Addendum: 1

Date: 08/14/2026

Project: Northwest Allen County Schools
Huntertown Elementary School Mechanical Upgrades

Comm #: 26842

TITLE:
ELECTRICAL
RISER
DEMOLITION
SHEET

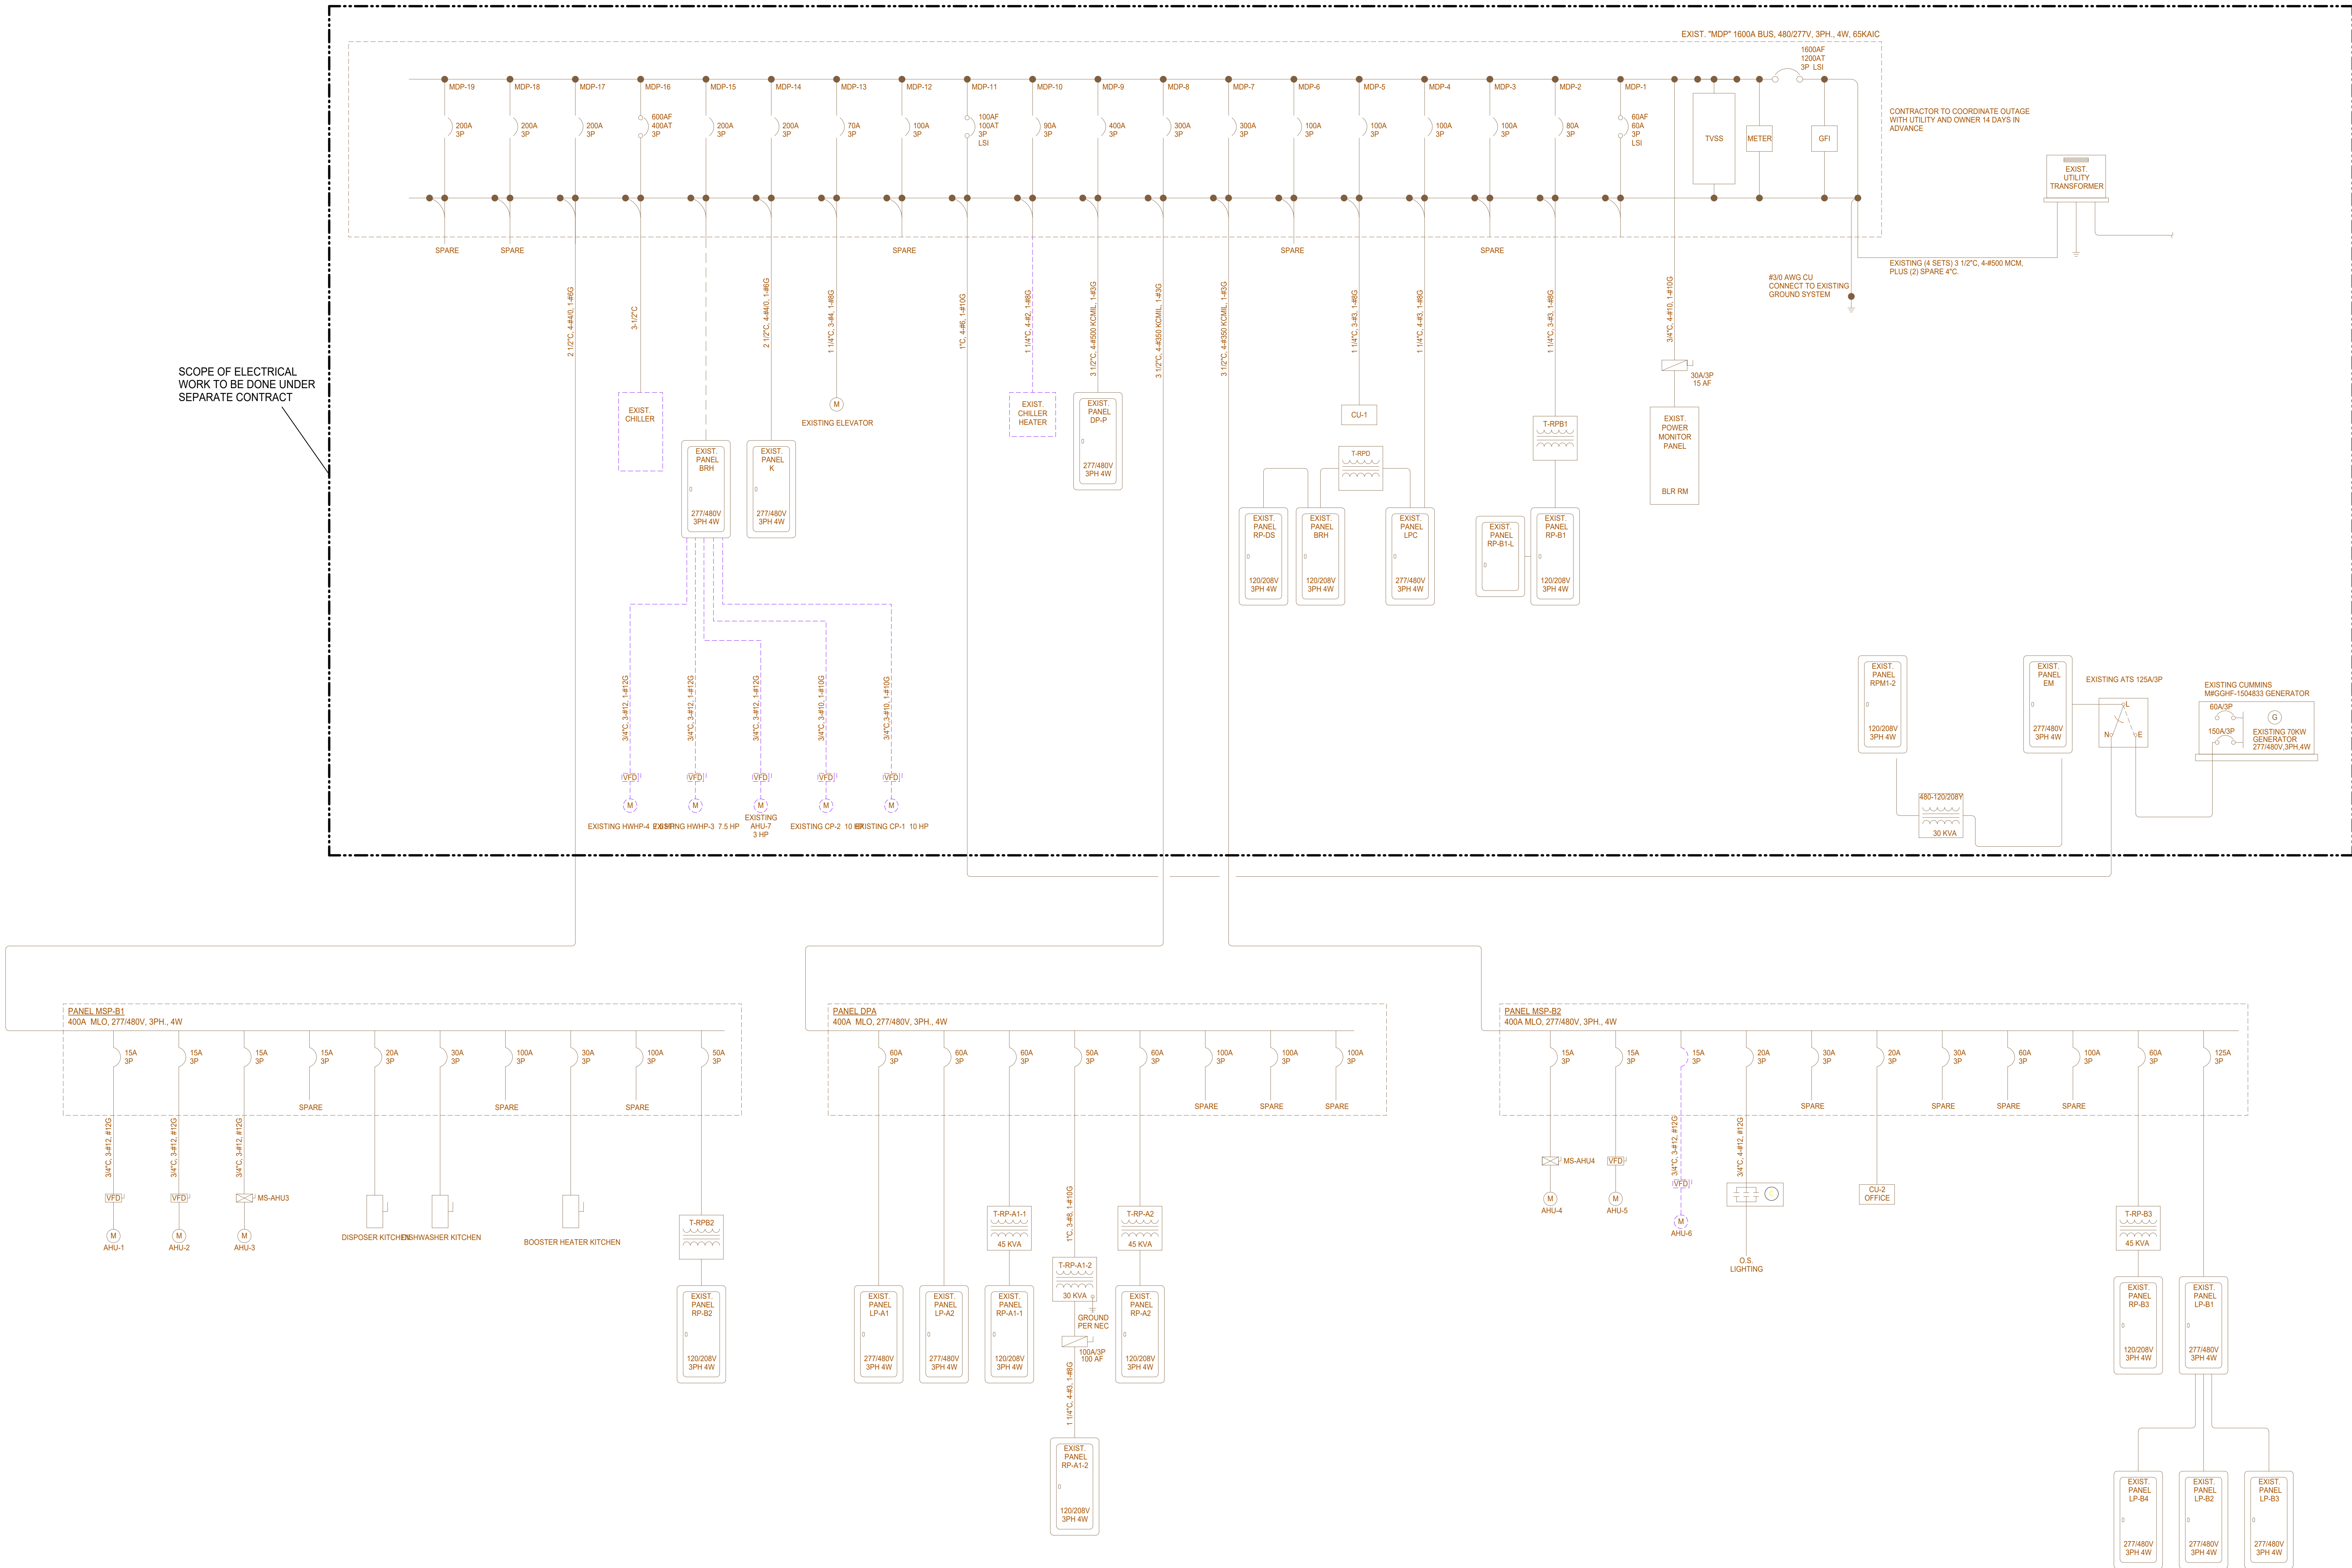
- A. Sheet added for further clarification and reference. Refer to supplemental sheet for more information.
